Memorandum

TO: Ivan Gall, Director
FROM: Ben Scandella, Darrick Boschmann; Groundwater Section
DATE: September 30, 2025
SUBJECT: Technical Evaluation of Petition to Amend Division 512

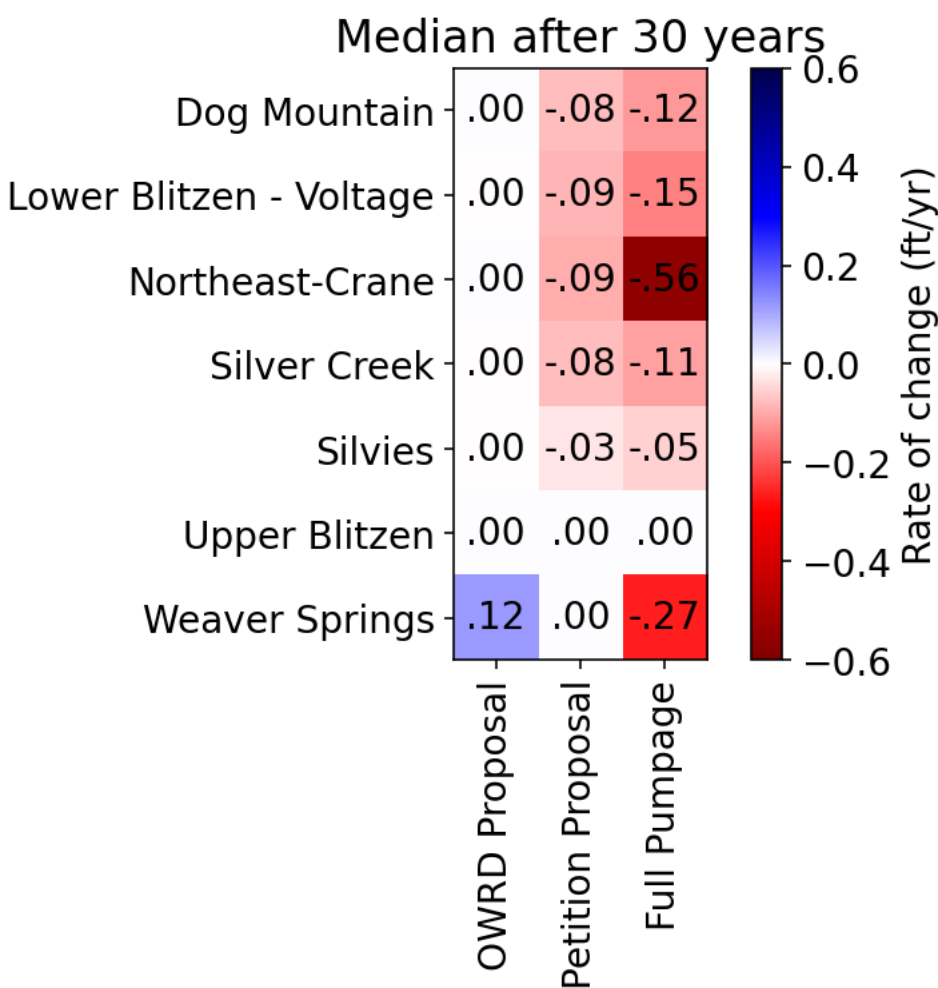
Under the OWRD Proposal the median groundwater level rate of change after 30 is stable in six subareas and rising in the Weaver Springs subarea. This is a direct result of optimizing the model to determine PTW in those subareas to meet the goal of stability in 30 years and explicitly setting the PTW in the Weaver Springs subarea.

Under the Petition Proposal the median groundwater level rate of change after 30 years is stable only in the Upper Blitzen and Weaver Springs subareas but remains in a state of decline in all other subareas.

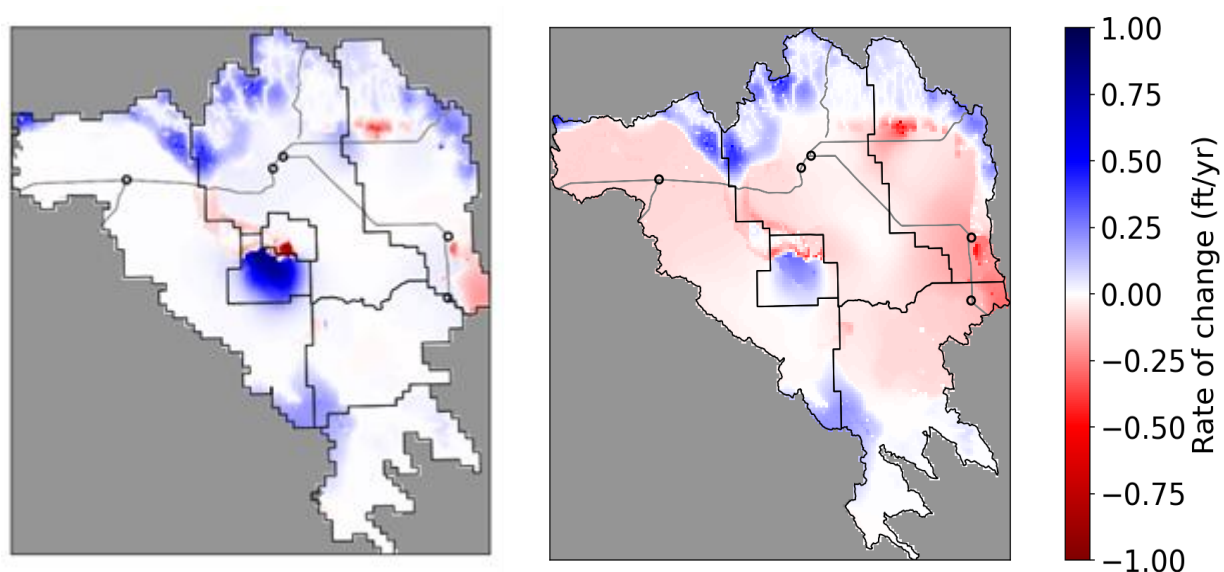
Under the OWRD Proposal (left) groundwater level rates of change after 30 years are stable or rising nearly everywhere. An area of rising groundwater levels is centered around the Weaver Springs subarea as the cone of depression in that area continues to recover. Small, localized areas of groundwater level declines also remain, primarily in the Dog Mountain subarea and in the northern and southern parts of the Crane-Buchanan subarea.

Under the Petition Proposal (right) groundwater level rates of change after 30 years are still declining across most of the GHVGAC. An area of rising groundwater levels is centered around the Weaver Springs subarea as the cone of depression in that area continues to recover.

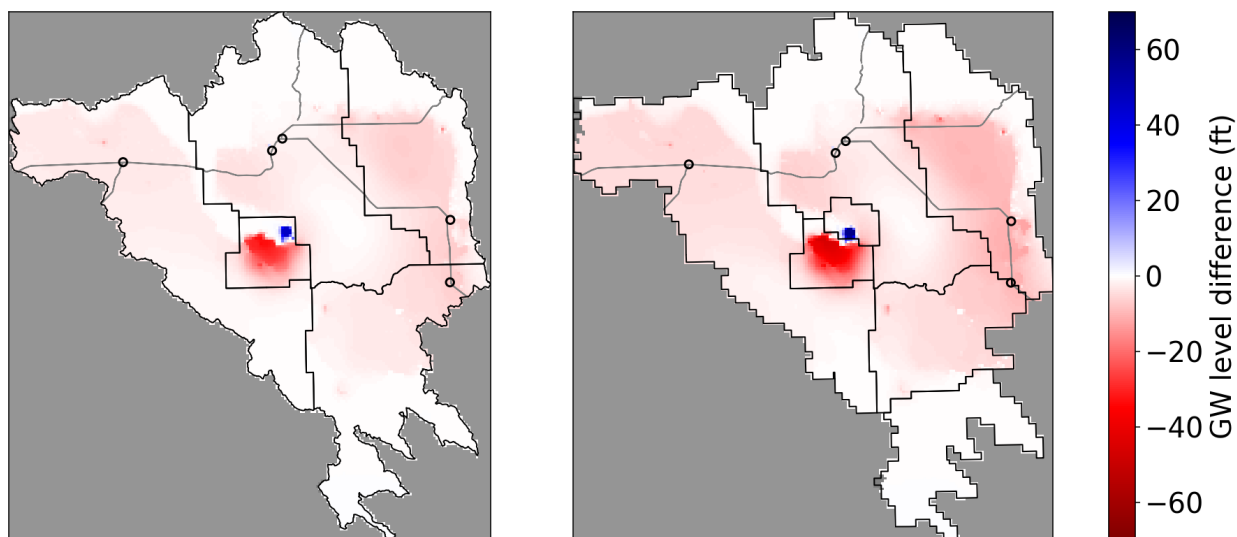
In nearly all areas groundwater levels in the Petition Proposal are lower than the OWRD Proposal (red) at 30 years and at the end of the model period. The areas of equal groundwater levels (white) around the margins of the map area reflect the influence of consistent recharge in those upland areas. The small, localized area of higher groundwater levels under the Petition Proposal (blue) near the center of the map area reflects differences in the boundary placement between the two proposals and the scale of pumping reductions in neighboring areas. In the Petition Proposal, this area falls within the Weaver Springs CGWA, which faces greater pumping reductions than the Dog Mountain subarea, where it is located under the OWRD Proposal.
